STAFF REPORT

SUBJECT: FP-2020-0001
Shelburne South No. 1

Final plat consisting of 59 buildable lots and 16 common lots on 16.61 acres of land in the R-8 zoning district.

B. Final Plat (dated: 8/18/20)

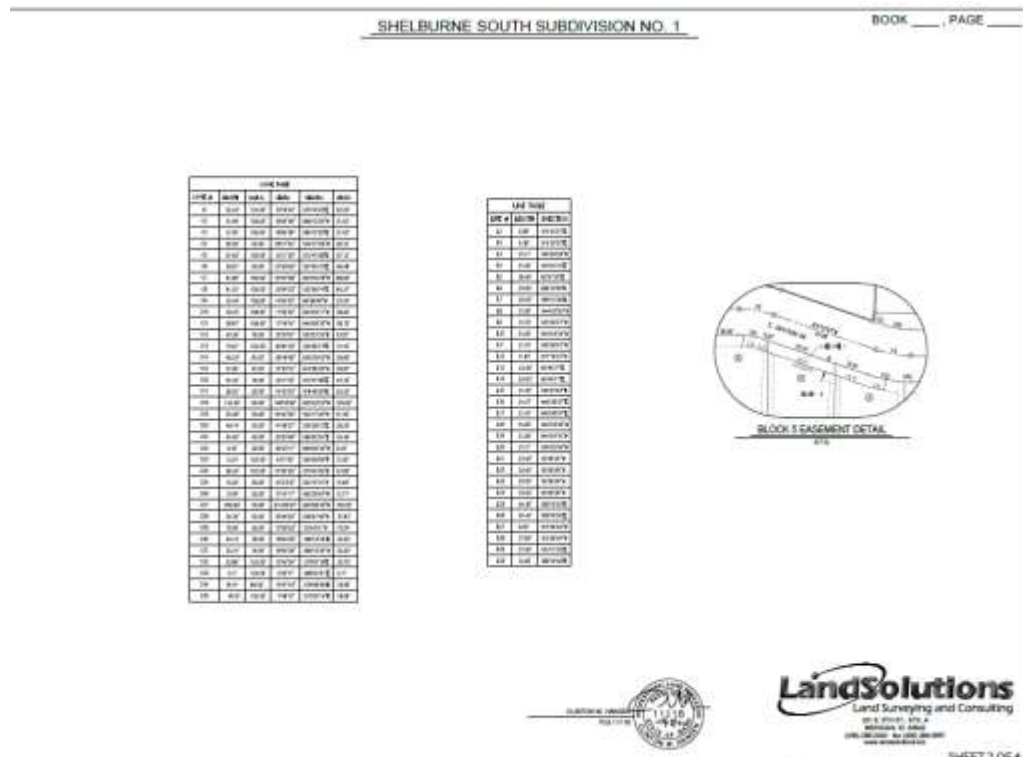
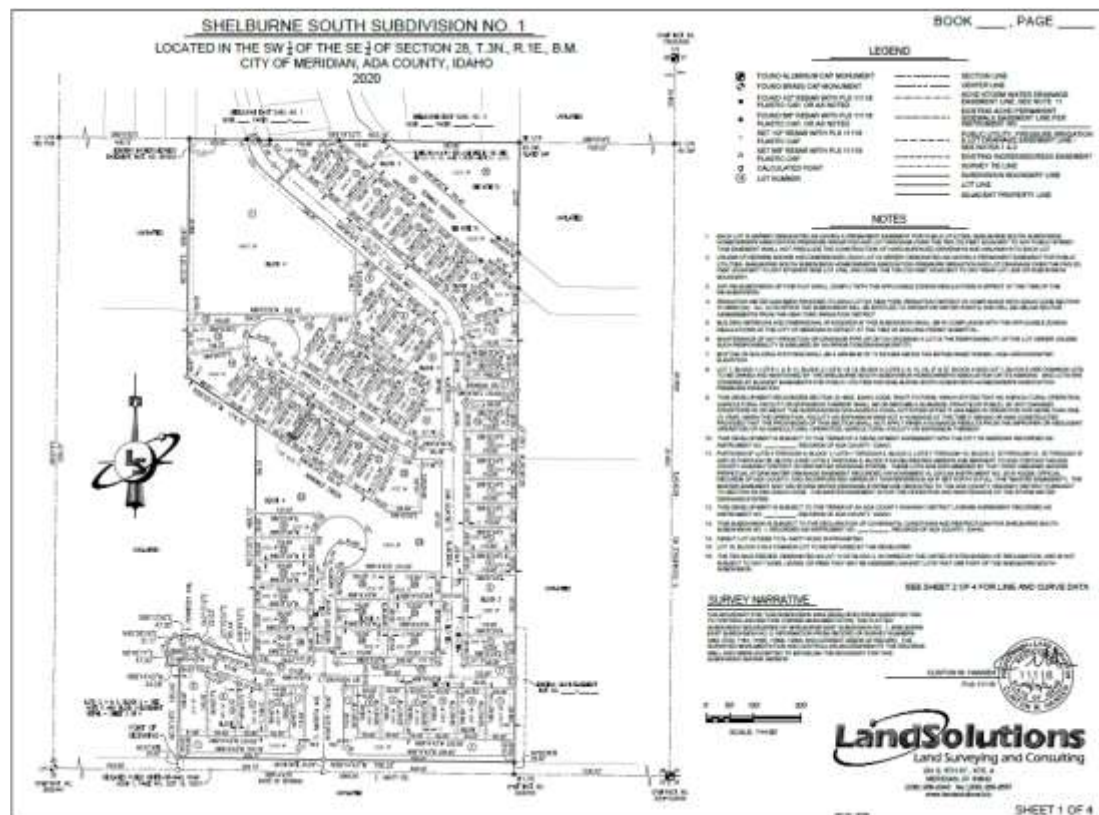
3. Prior to submittal for the City Engineer's signature, have the Certificate of Owners and the accompanying acknowledgement signed and notarized.
4. The final plat prepared by Land Solutions, stamped by Clinton W. Hansen, dated: 8/18/2020, included in Section V.B shall be revised as follows:

- a. Note #10: Include the recorded instrument number of the Development Agreement (#2020-138124).
 - b. Note #12: Include the recorded instrument number of the

- c. Note #13: Include the recorded instrument number of the CC&R's.
 - d. Include the recorded Book and Page numbers for Shelburne East Subdivision No. 1 and No. 2 graphically depicted on Sheet 1.

- e. Include the recorded instrument number for the existing slope easement graphically depicted on Sheet 1.
 - f. Include the recorded instrument number of the existing ACHD permanent sidewalk easement line in the Legend on Sheet 1.

A copy of the revised plat shall be submitted for City Engineer signature.

LANDSCAPE IMPROVEMENT PLANS FOR SHELburne SOUTH - PHASE 1 SUBDIVISION

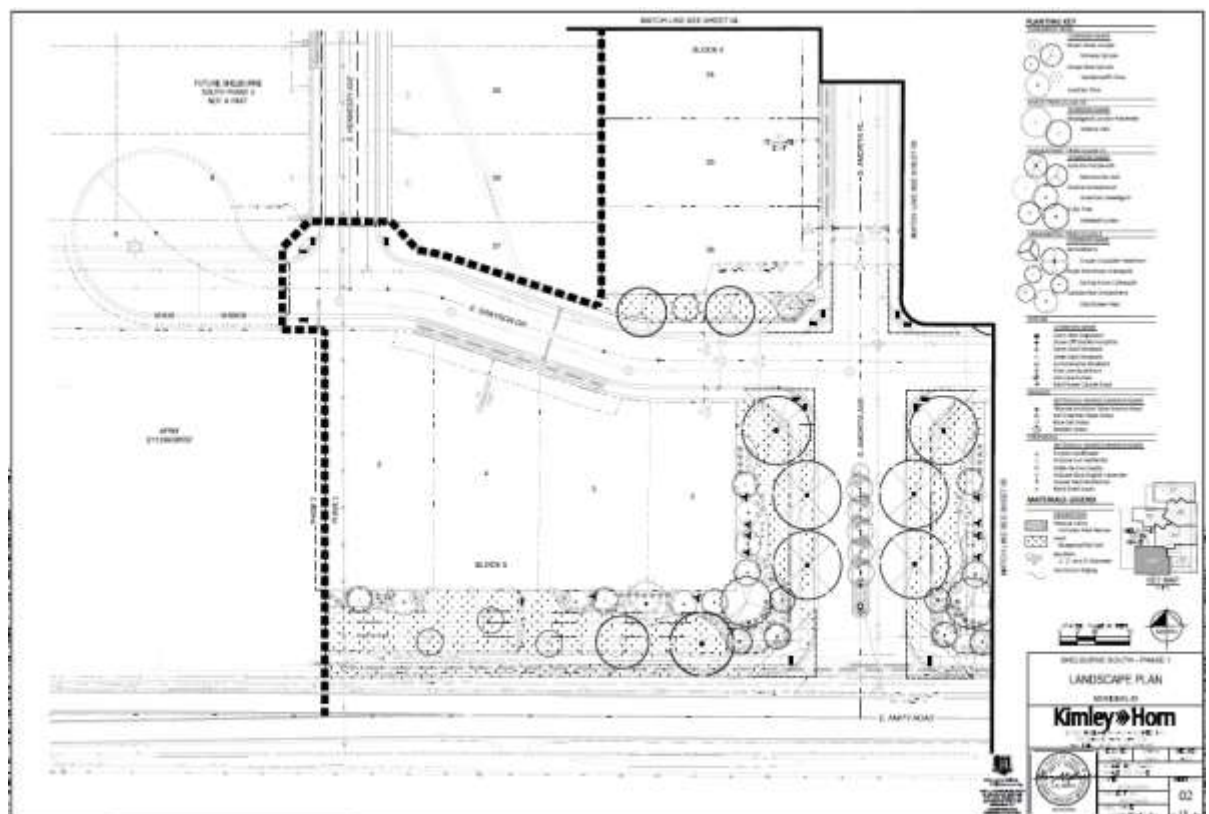
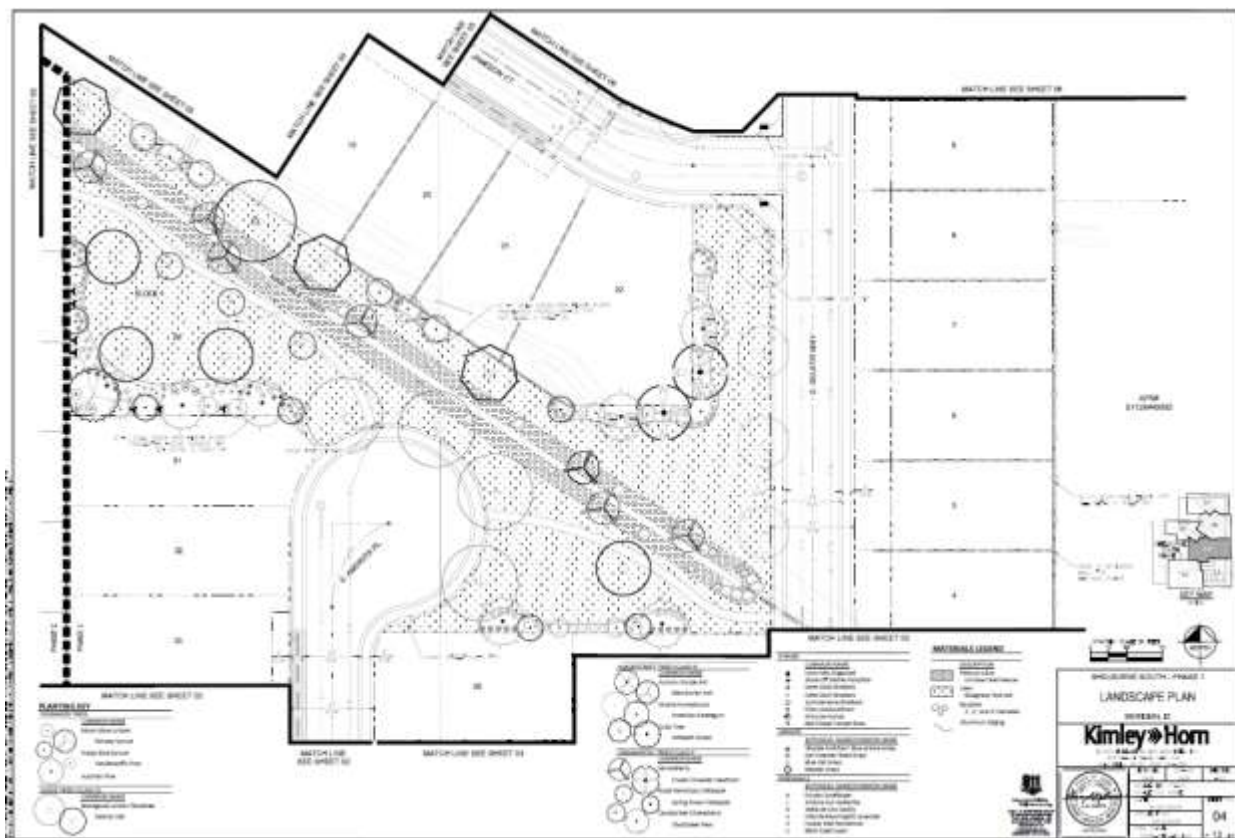
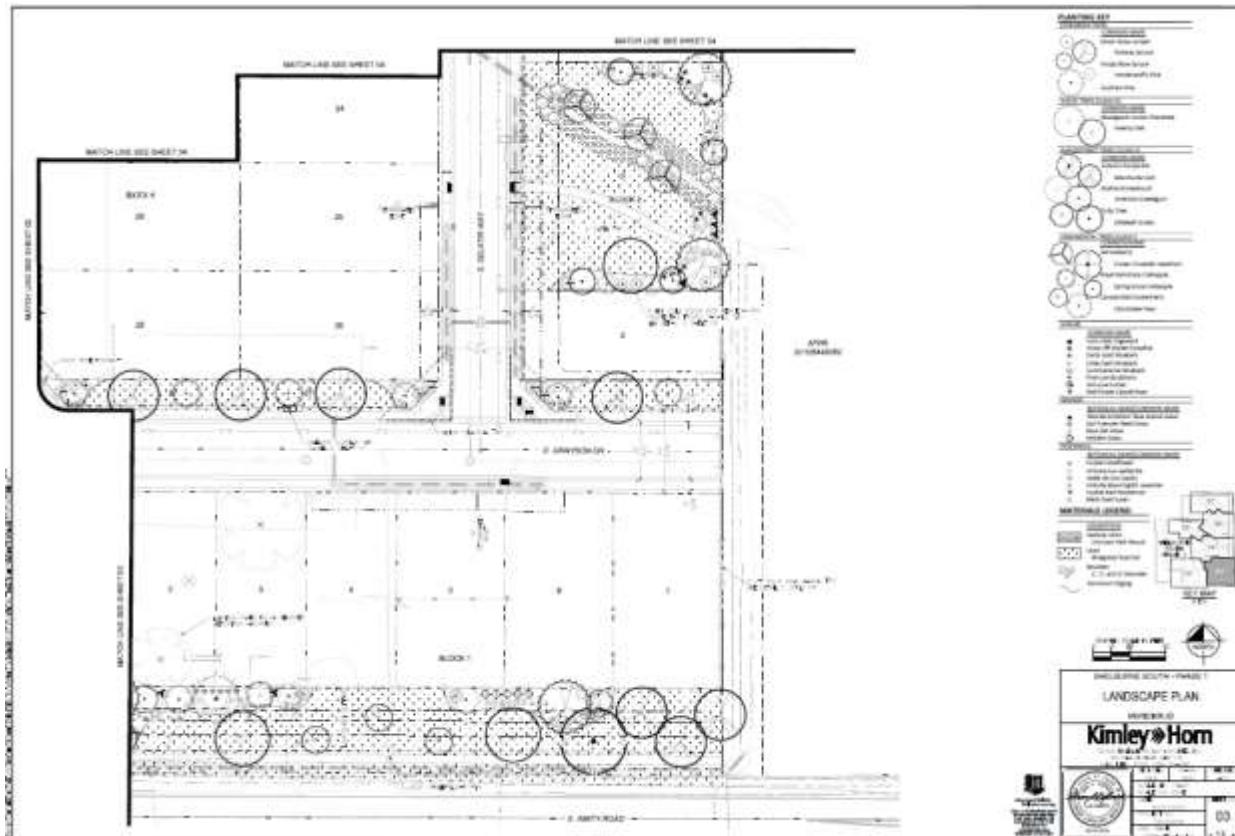
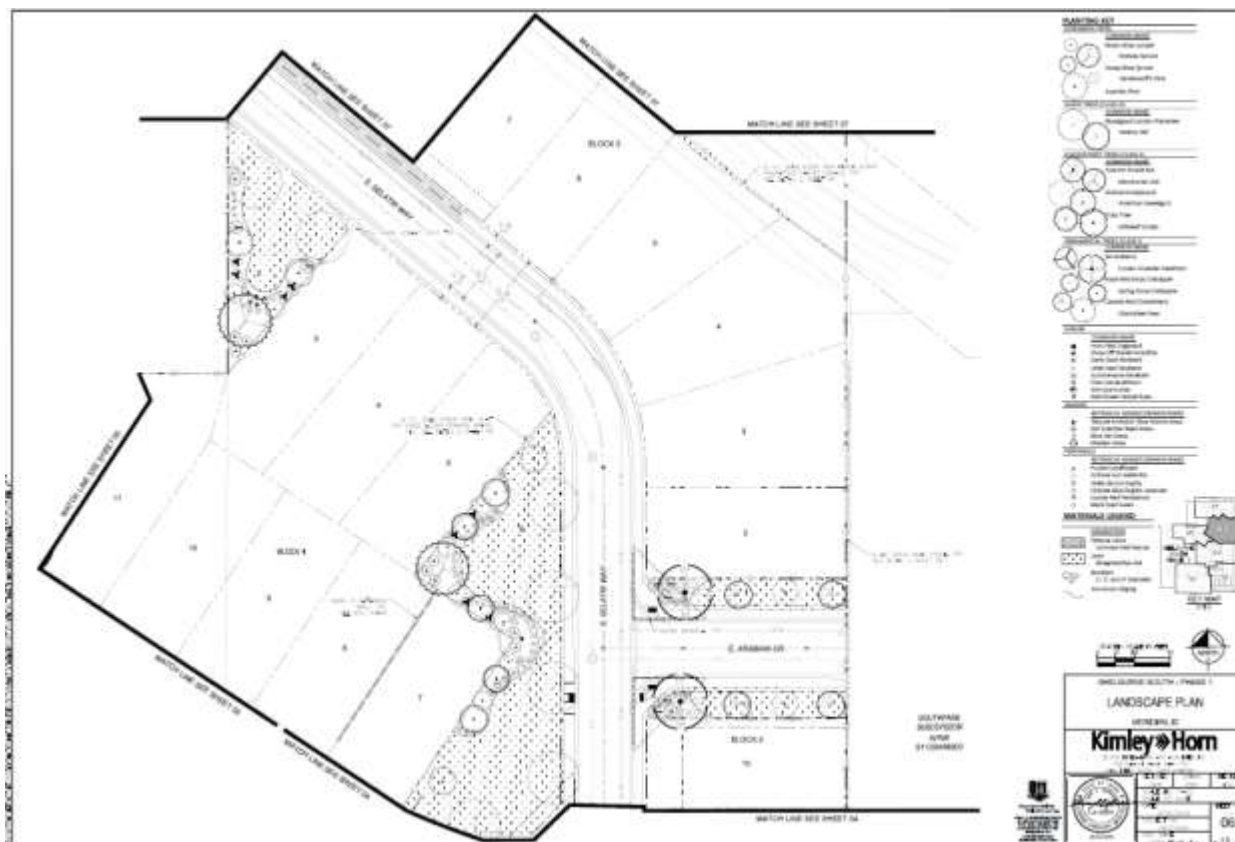
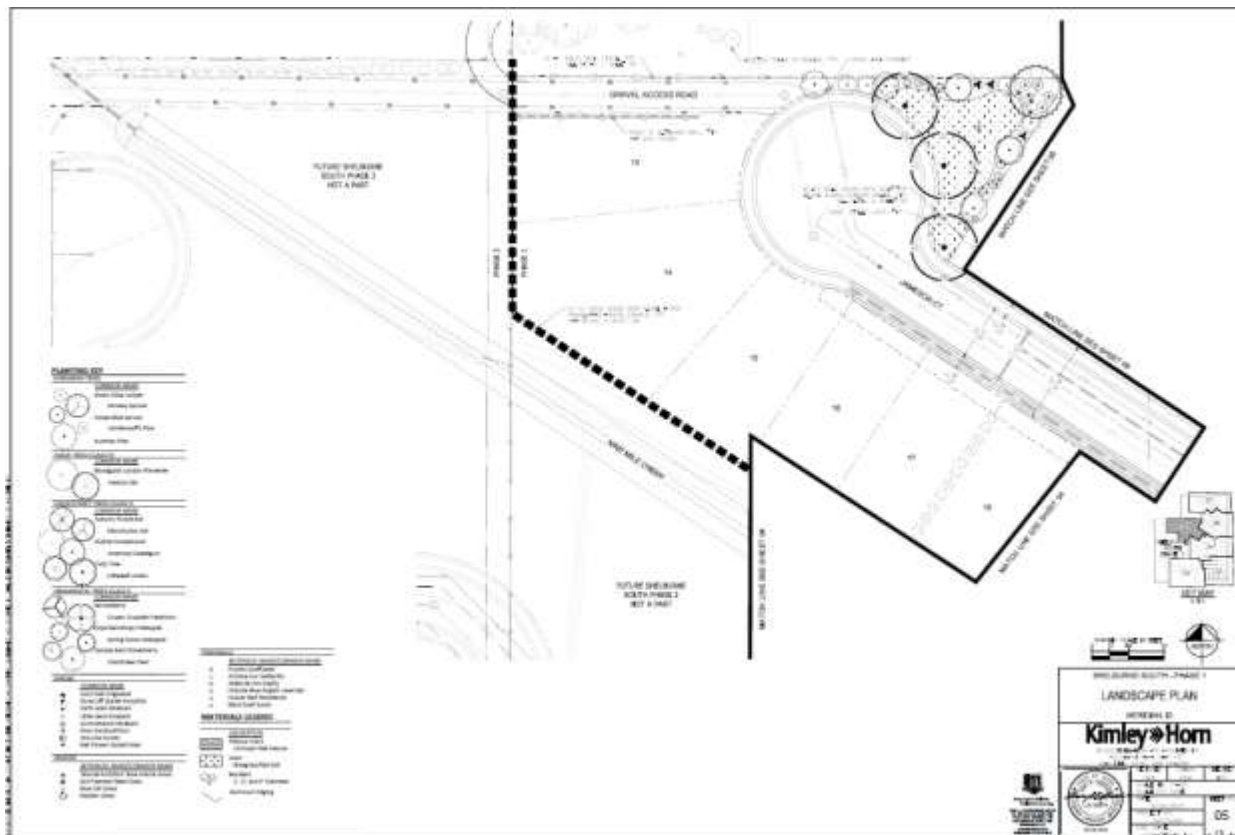
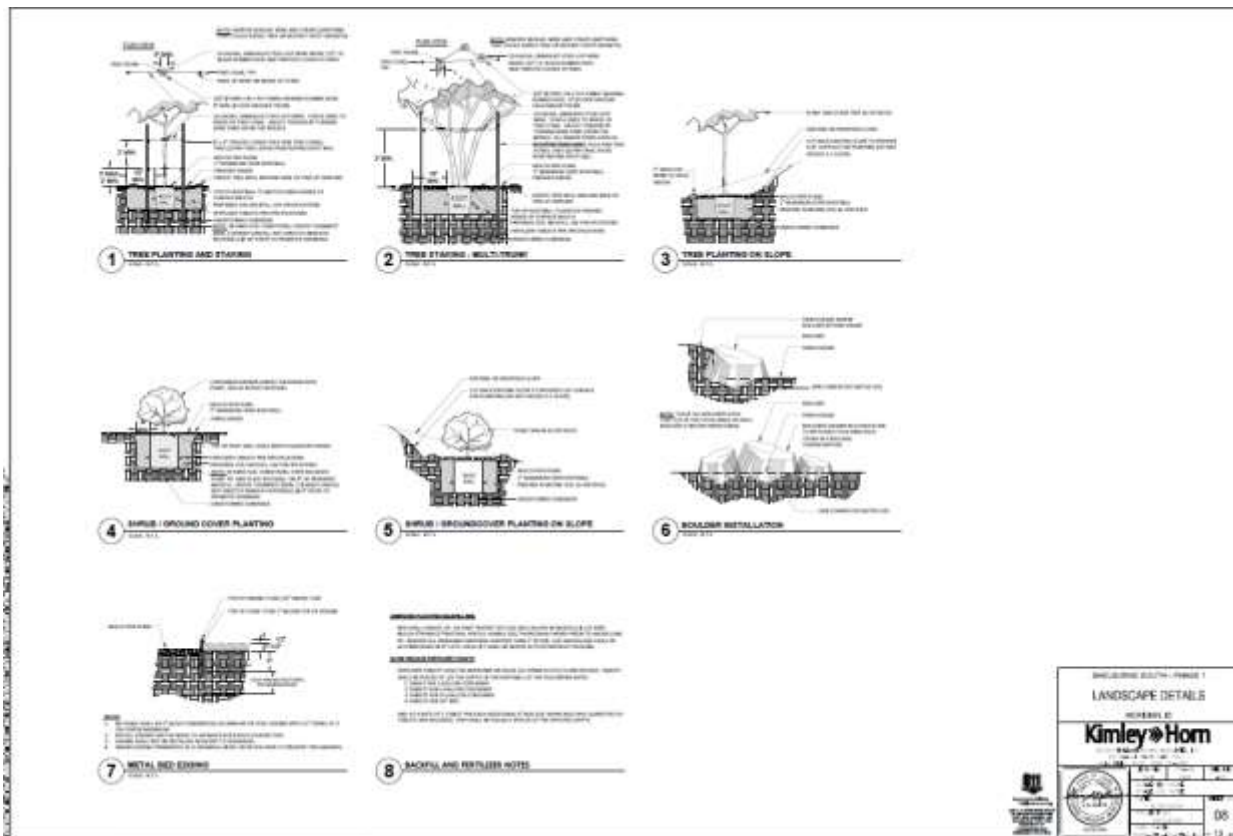
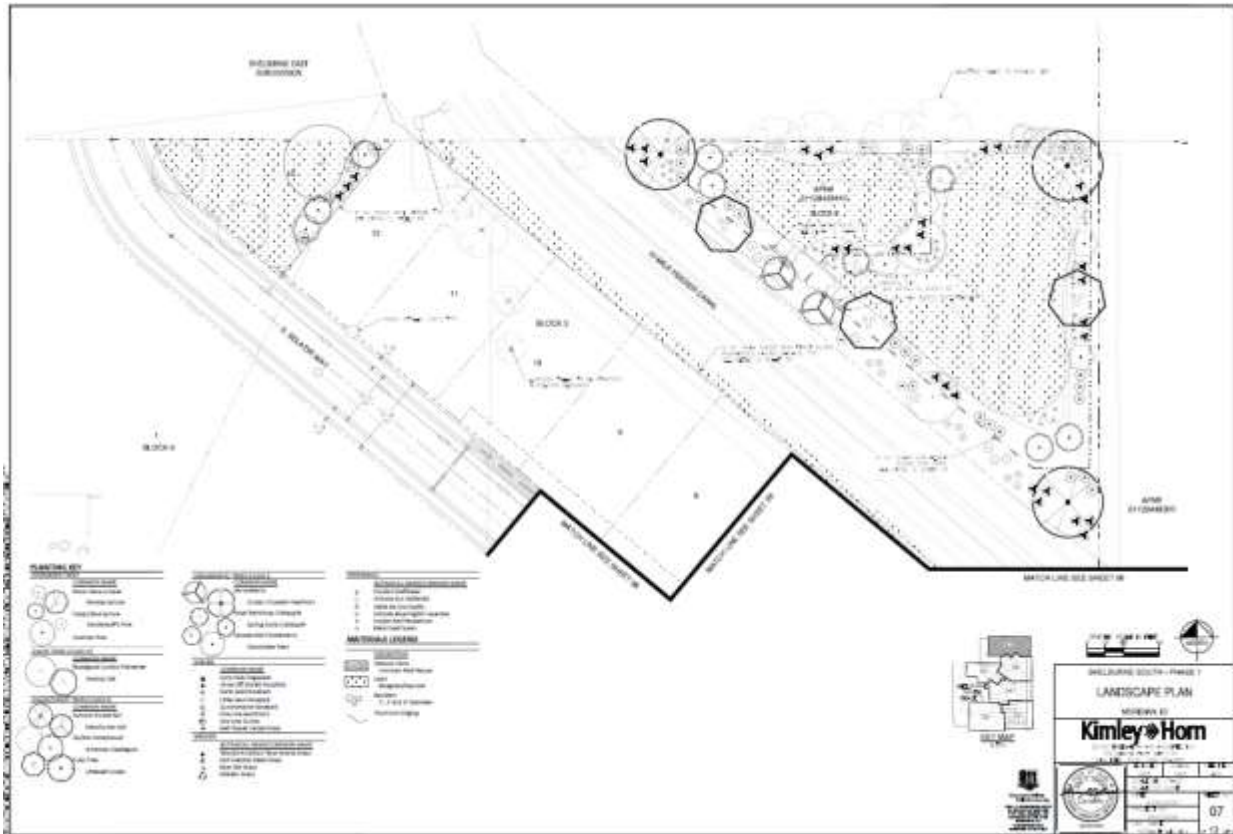
5. The landscape plan prepared by Kimley-Horn, dated 08/26/2020, included in Section V.C, shall be revised as follows:
 - a. Depict mitigation trees and calculations on the plan in accord with the standards listed in UDC 11-3B-10C.5. *Coordinate with Matt Perkins, the City Arborist, to determine mitigation requirements.*

- b. Revise the configuration of the pathway on Lot 3, Block 2 so that it runs parallel with the creek in closer alignment with the pathway on Lot 23, Block 4.

- c. If the unimproved right-of-way of E. Amity Rd. is 10 feet or greater from the edge of pavement to edge of sidewalk or property line, the Developer is required to maintain a 10 foot compacted shoulder meeting the construction standards of ACHD and landscape the remainder with lawn or other vegetative ground cover as set forth in UDC 11-3B-7C.5. A license agreement for improvements within the right-of-way is required between the property owner and ACHD.

- d. Depict 5-foot wide landscape strips on each side of the multi-use pathway that comply with the standards listed in UDC 11-3B-12C. *A mix of trees, shrubs, lawn and/or other vegetative groundcover is required.*
